PLIMMERTON FARM - PLAN CHANGE PROPOSAL

Supporting Documentation

Karla and Trevor Beamsley
24 Motuhara Road
Plimmerton

Figure 2 Scale diagram showing an 11.7m road cut into a 1 in 5 slope and the resulting affected area.

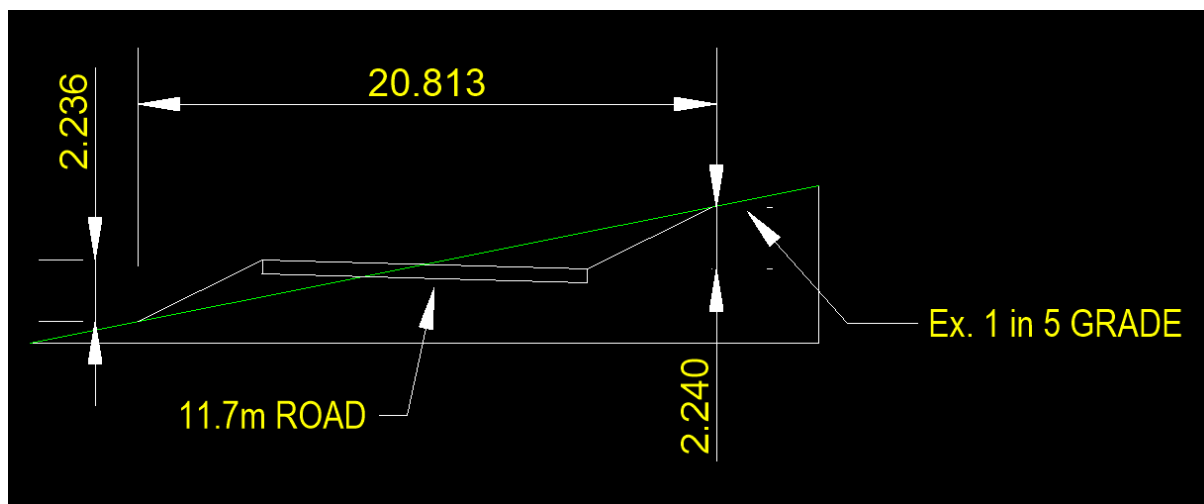
PCC need to demonstrate how the proposed road typologies would be able to comply with ECO_{PFZ}-P1, it is possible to avoid significant adverse effects when you're building a road through a SNA or would it immediately revert to remedy and mitigate and the natural value of the SNA will be diminished.

The minimum road width is 11.7m. The SNA on the site has an average grade of 1 in 5. In order to get a road of this width on this slope would result in a minimum disturbed width of almost 21m to allow for plantable batter slopes of 50%.

Figure 3 Annotated Screen grab from Attachment 13 drawing OA-930

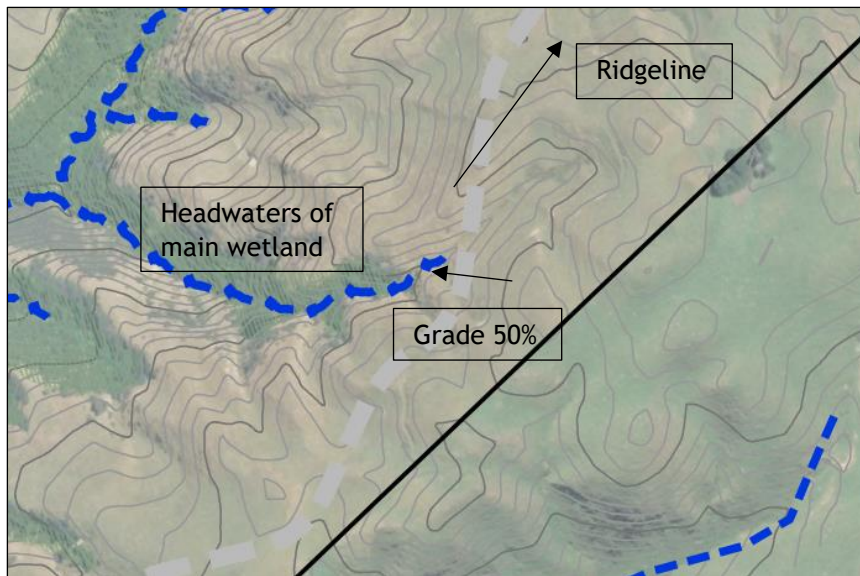
Additionally, within the SNA, along the road alignment depicted on the infrastructure plans, grades can reach up to 1 in 2 (or 50%), which would disturb a far greater area, and mean either steeper batter slopes that won't hold topsoil or plants and be more susceptible to scour, or large scale earthworks at the headwaters of the wetland to regrade the natural slopes and potentially alter the highly visible ridgeline. In addition to this, the geotechnical report classed this area as Area D - an area of active, larger scale slope instability.

VISUAL AMENITY IMPACT OF PLIMMERTON FARM PROPOSAL

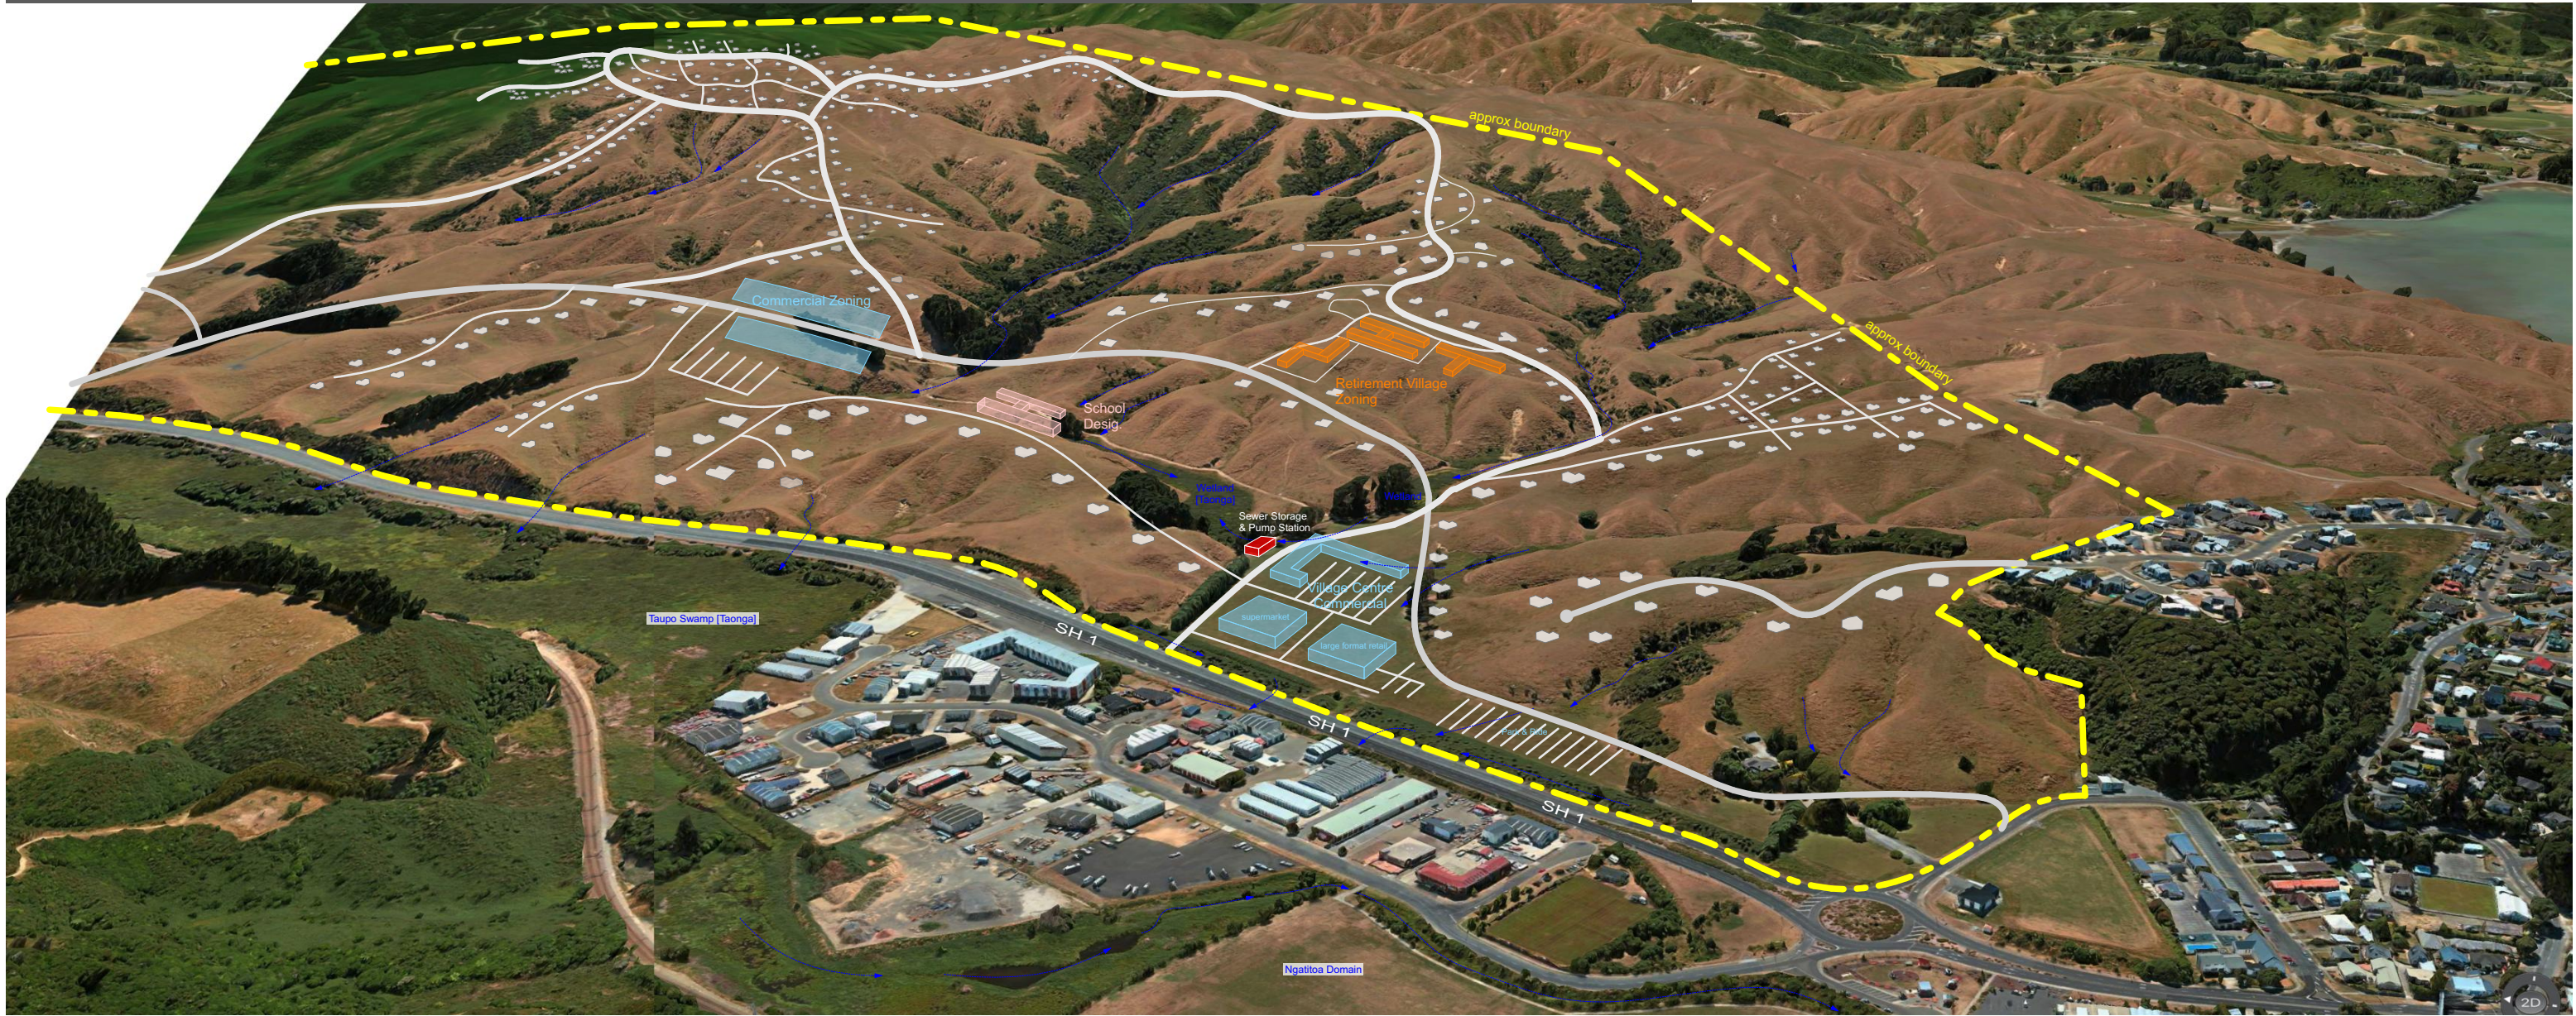
- The site overlay is of the partial site only, the northern most boundary is cropped
- The Plimmerton Farm proposal is for 1,550 house Lots.
- The overlay visualisation shows 340 house Lots far less than the proposed 1,550 Lots.
- Building shape & typology is indicative
- Conflicting information between Urban Design & Traffic Report with regards to road configuration.

The Urban design masterplan is based on flat topography. In order to achieve this proposal at Plimmerton Farm it will involve extensive "flattening/benching" of farm land to create flat building platforms and roads.

- Extensive cut & fill earthworks required to build over streams & gullies
- Visual amenity impact of extensive retaining walls and benching
- Significant ridge lines would require cutting resulting in visual impact [suggest implementing a rule similar to WCC Coastal Escarpment rule with a no build RL level]
